ADDENDUM No. 04

Subject: Wright Elementary School – Major HVAC Renovation
SDP Contract No.

This ADDENDUM dated February 2, 2022 shall modify and become part of the Contract Documents for the work of this project. Any items not mentioned herein, or affected by, shall be performed strictly in accordance with the original documents.

DRAWING NO.
EL103
SHEET 68 OF 69

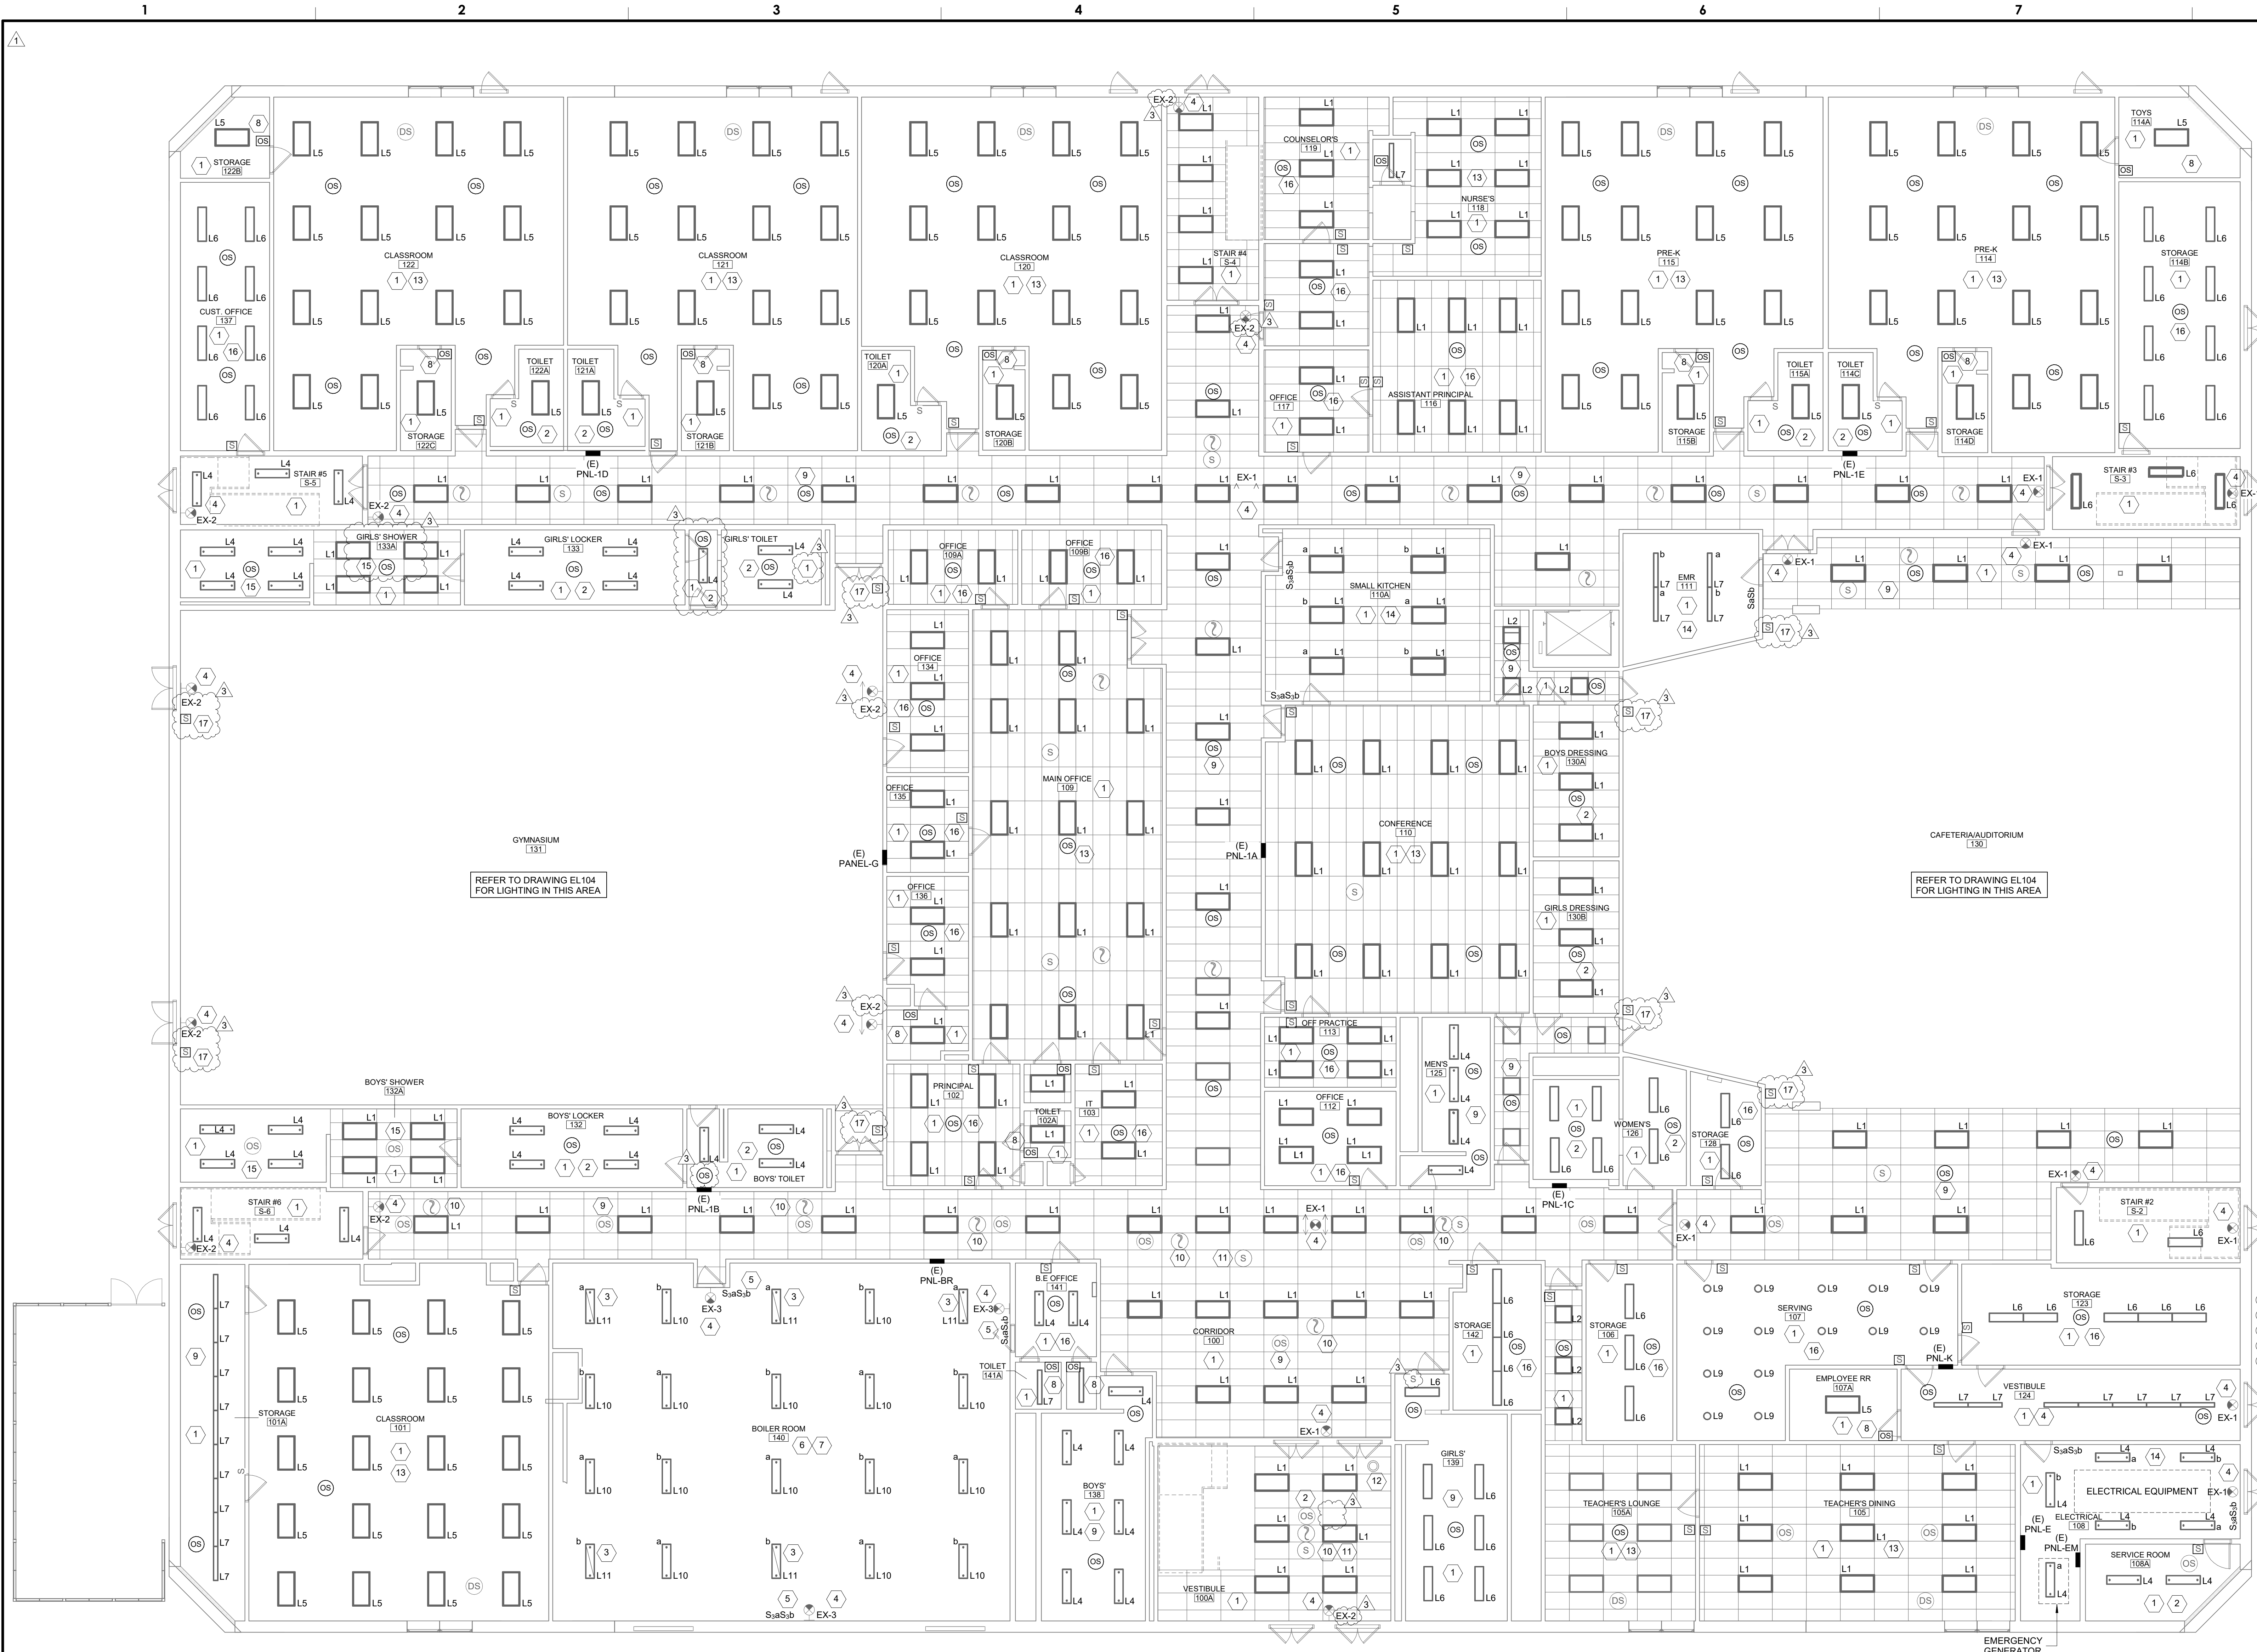
On drawings EL103 and EL104, please confirm the symbol “DS” refers to a daylight sensor. This symbol is not shown on the symbols list.

Please confirm the lighting controls mentioned keynotes 13 and 16 on EL103 and keynotes 10 and 12 on EL104 are digital. These keynotes reference spec section 260923 (distributed in addendum #3), and the basis of design model numbers in these specs are for a digital system.

It seems keynote 16 on EL103 is cut off, as it says "...with vacancy sensing occupant detectors and low refer to specifications..." It is assumed that this keynote is meant to call for digital similar to keynote 13. Please confirm our assumption is correct. Additionally, please confirm if we are to provide on/off/dim or just on/off switches. [This question allow applies to keynotes 10 and 12 on EL104.]

On EL103, Vestibule 100A has keynote 2 (line voltage occupancy sensor) and keynote 9 (low voltage occupancy sensor with power pack) at the occupancy sensor. Please confirm we are to provide devices per keynote 9 to match the rest of the corridors.

On EL103, please clarify what type of switch should be provided in Service Room 108A. Per keynote #2, we are to provide a line voltage occupancy sensor in this room, but the type of switch is unclear.

On EL103, for vestibule 124, please clarify what type of occupancy sensor should be provided, as there is no keynote to clarify low voltage with power pack, line voltage, or digital.

Confirmed, the “DS” symbol represents a daylight sensor.

Confirmed, the controls required by the referenced drawing keynotes are digital systems as specified in Section 260923.

Keynote #16 on EL103 is to read, "PROVIDE A LOW VOLTAGE LIGHTING CONTROL SYSTEM FOR THIS SPACE CONSISTING OF A LOCAL ROOM LIGHTING CONTROLLER; WITH VACANCY SENSING OCCUPANT DETECTOR(S) AND LOW VOLTAGE ON/OFF CONTROL SWITCH(ES). REFER TO SPECIFICATIONS, SECTION 26 09 23." The same is true for Keynote #12 on EL104. (To clarify, Keynotes #13 (EL103) and #10 (EL104) are digital lighting control systems with manual dimming (on/off/dim switches). Keynotes #16 (EL103) and #12 (EL104) are digital lighting control systems with manual on/off control switches.)

Since the vestibule requires only a single occupancy sensor, the design intent is to utilize a line voltage device in Vestibule 100A as per Keynote #2.

Keynote #2 in Service Room 108A is incorrect; this should be Keynote #16. Provide a digital lighting control system with a vacancy-sensing occupant detector and a low voltage on/off control switch.

In Vestibule 124, provide low voltage occupancy sensors with a power pack as per Keynote #9.

DRAWING NO.
EL104
SHEET 69 OF 69

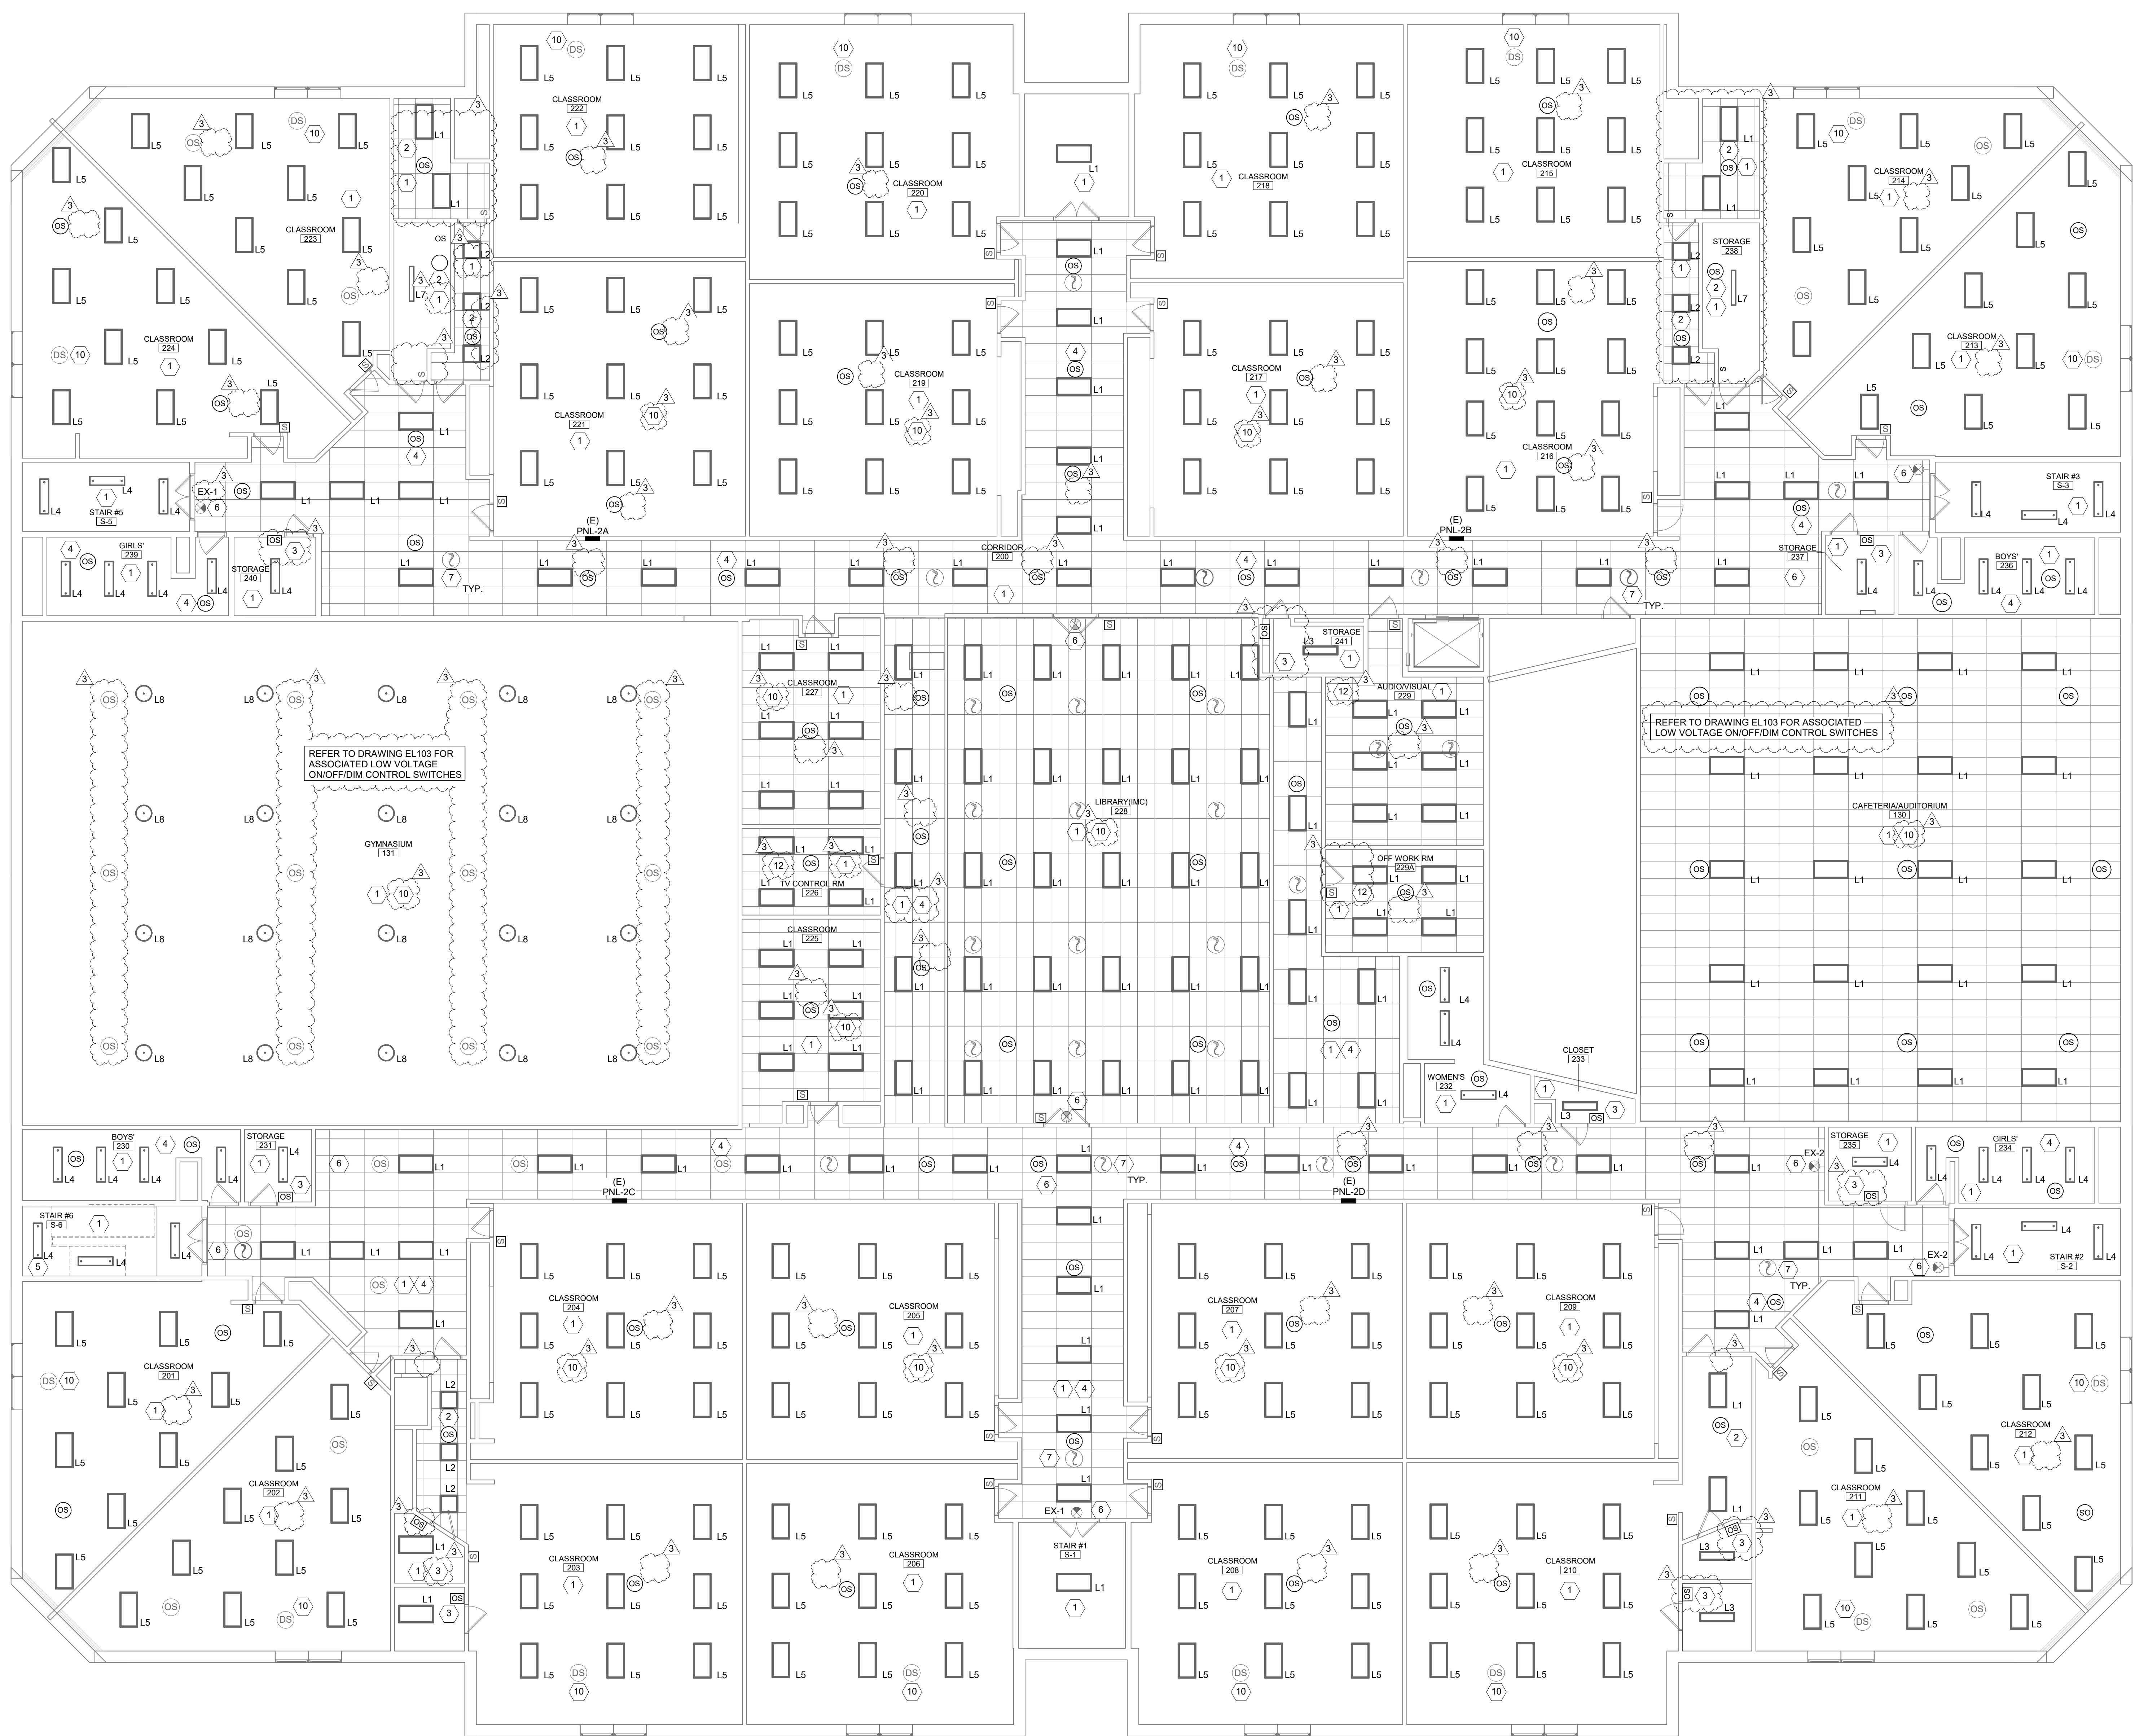
On EL104, please clarify what type of switch should be provided in rooms 227, 225, 229, 229A, and 238. Per keynote #2, we are to provide a line voltage occupancy sensor in this room, but the type of switch is unclear.

On EL104, rooms 201, 202, 211, 212, 213, 214, 223, 224 have both keynotes #4 at the occupancy sensor (low voltage occupancy sensor with power pack) and keynote 10 at the daylight sensor (assuming digital sensor based on reference to spec section 260923). Please confirm the occupancy sensor should be a digital sensor, not a low voltage sensor with a power pack. If low voltage with power pack, please clarify what kind of switch to provide in these rooms.

On EL104, rooms 222, 220, 218, 215, 203, 206, 208, 210 have both keynotes #2 at the occupancy sensor (line voltage occupancy sensor) and keynote 10 at the daylight sensor (assuming digital sensor based on reference to spec section 260923). Please confirm the occupancy sensor should be a digital sensor, not a line voltage sensor. If line voltage, please clarify what kind of switch to provide in these rooms.

On EL104, rooms 219, 217, 204, 205, 207, 209 have keynote #2 at the occupancy sensor (line voltage occupancy sensor). However, we believe based on the other classroom designs in this project, that we should be providing a digital lighting control system in this room (e.g. keynote 10). Please confirm we are to provide digital devices per keynote 10. If line voltage, please clarify what kind of switch to provide in these rooms.

On EL104, room 216 has keynote 2 (line voltage occupancy sensor) and also keynote 4 (low voltage occupancy sensor with power pack) at the occupancy sensors. Please confirm both of these keynote references are incorrect, and that we are to provide digital devices per keynote 10. If line voltage or low voltage with power pack, please clarify which of the 2 options we should follow, and clarify what type of switch should be provided.

On EL104, room 221 has keynote 4 (low voltage occupancy sensor with power pack) at the occupancy sensors. Please confirm this keynote is incorrect, and that we are to provide digital devices per keynote 10. If low voltage with power pack, please clarify what kind of switch to provide in this room.

On EL104, the small room to the right of room 223 has keynote 2 (line voltage occupancy sensor) and keynote 12 (assuming digital sensor based on reference to spec section 260923). Please confirm keynote 2 is incorrect, and that we are to provide digital devices per keynote 12. If line voltage, please clarify what kind of switch to provide in this room.

On EL104, for room 232, please clarify what type of occupancy sensor should be provided, as there is no keynote to clarify low voltage with power pack, line voltage, or digital.

On EL104, for room 226, please clarify what type of occupancy sensor and switch should be provided. There is no keynote to clarify low voltage with power pack, line voltage, or digital occupancy sensor, and it is unclear what switch type to provide.

Keynote #2 in Classroom 227, Classroom 225, A/V 229, and Work Room 229A is incorrect; the correct notes are Keynote #10 for Classrooms 225 & 227 (low voltage on/off/dim digital controls) and Keynote #12 for A/V 229 & Work Rm 229A (low voltage on/off digital controls). For Storage 238, provide a line voltage single-pole light switch for manual override Off.

In ALL Classrooms, the correct note is Keynote #10. ALL Classrooms are to be provided with a digital low voltage control system with vacancy-sensing occupant detectors and low voltage on/off/dim control switches.

In ALL Classrooms, the correct note is Keynote #10. ALL Classrooms are to be provided with a digital low voltage control system with vacancy-sensing occupant detectors and low voltage on/off/dim control switches.

In ALL Classrooms, the correct note is Keynote #10. ALL Classrooms are to be provided with a digital low voltage control system with vacancy-sensing occupant detectors and low voltage on/off/dim control switches.

In ALL Classrooms, the correct note is Keynote #10. ALL Classrooms are to be provided with a digital low voltage control system with vacancy-sensing occupant detectors and low voltage on/off/dim control switches.

In ALL Classrooms, the correct note is Keynote #10. ALL Classrooms are to be provided with a digital low voltage control system with vacancy-sensing occupant detectors and low voltage on/off/dim control switches

Keynote #2 applies to this room (Keynote #12 should be deleted). Provide a line voltage single-pole light switch for manual override Off.

In Women's Room 232, provide low voltage occupancy sensors with a power pack as per Keynote #4.

For TV Control Room 226, provide a digital low voltage control system with a low voltage on/off control switch, as per Keynote #12.
